BUREAU OF LAND MANAGEMENT

3482
U-47979
(U-065c)

Re: Deer Creek Mine Resource Recovery and Protection Plan (R2P2), 8th East Longwall Panel

ENCLOSURE - 1
 Original location of
 set-up rooms and
 bleeder entries

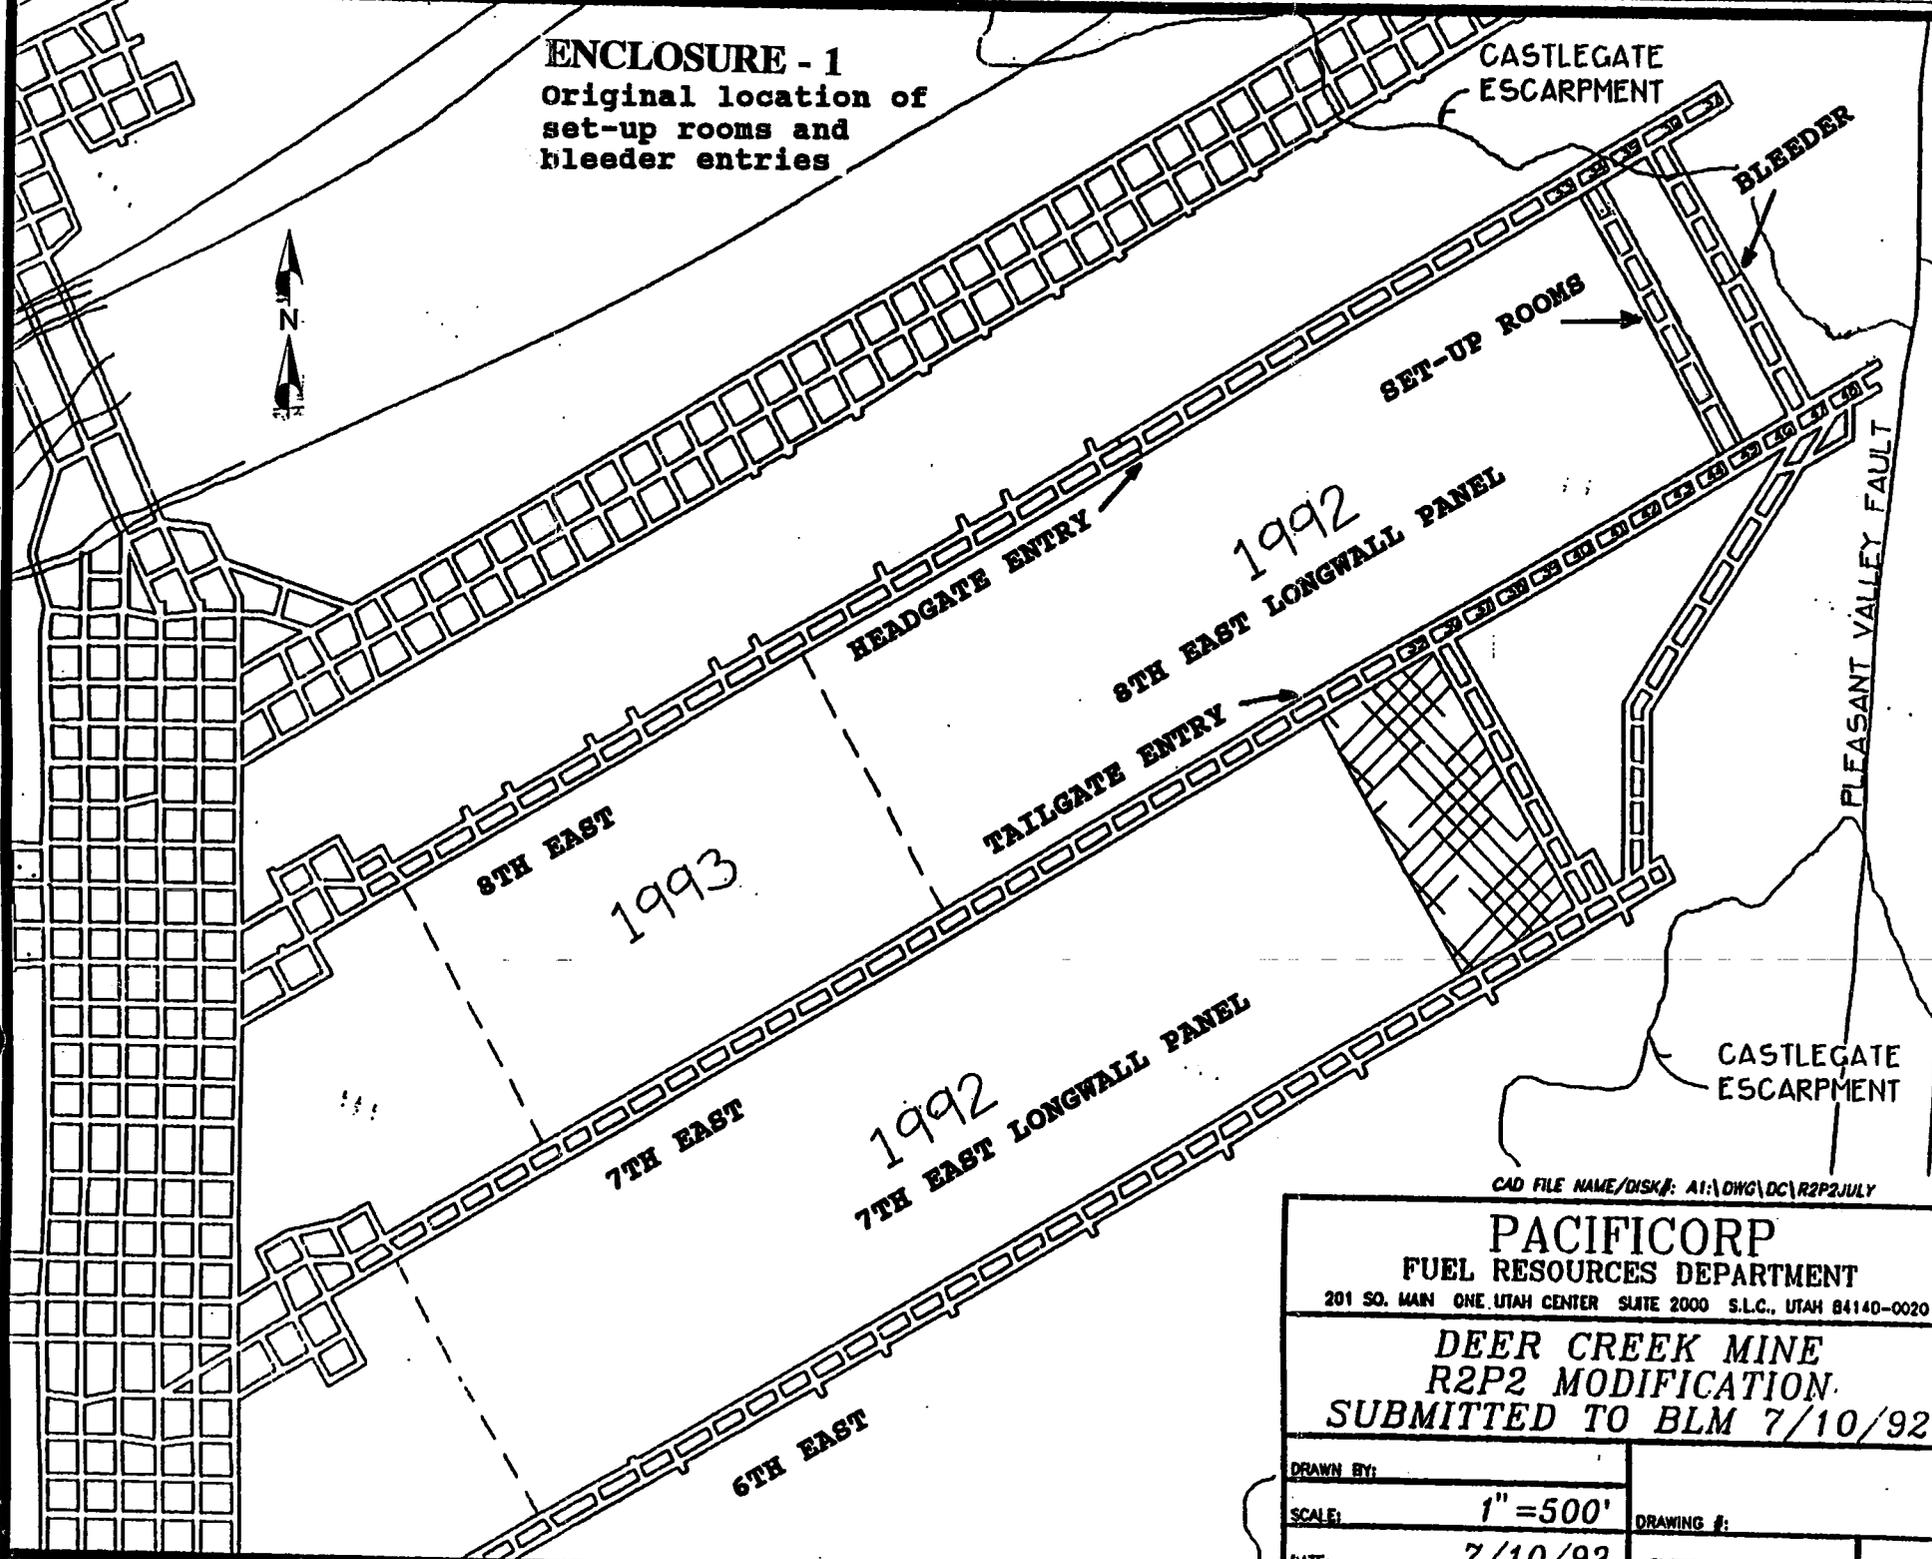
According to the approved R2P2 for the Deer Creek Mine, the 8th East longwall panel's set-up rooms and bleeder entries were to traverse the panel from crosscuts 33 and 35 respectively in the 8th East headgate entries to crosscuts 44 and 46 respectively in the 7th East tailgate entries. PacifiCorp's modification changes the approved R2P2 by relocating the set-up rooms and bleeder entries inby 200 feet from crosscuts 35 and 37 respectively in the 7th East headgate entries to crosscuts 46 and 48 respectively in the 7th East tailgate entries (Enclosure 1).

PacifiCorp proposes to increase the length of the 8th East longwall panel because the actual fault location is approximately 200 feet inby the projected location. The original panel length was planned according to the projected location of the fault.

On May 14, 1992, Barry Grosely, BLM mining engineer, performed an inspection of the Deer Creek Mine. The fault location was observed in the 7th East tailgate entries at the face inby crosscut 48. When the 8th East headgate entries were driven to crosscut 37, B. Grosely performed another inspection on July 29, 1992, in the 8th East headgate entries from crosscuts 35 through 37. There was no indication of the fault and the face was in excellent condition.

In analyzing the proposed change, the BLM agrees that the set-up rooms should be moved inby the original location and commends PacifiCorp for the additional coal recovery from this panel.

The BLM has determined that the proposed modification complies with the Mineral Leasing Act of 1920, as amended, the regulations at 43 CFR 3480, the lease terms and stipulations, and will achieve maximum economic recovery of the Federal coal. The proposed modification is approved and confirms the verbal approval given to PacifiCorp on July 29, 1992. By relocating the set-up rooms inby 200 feet, an additional 47,000 tons of coal will be mined. A copy of the approved mine map is enclosed.
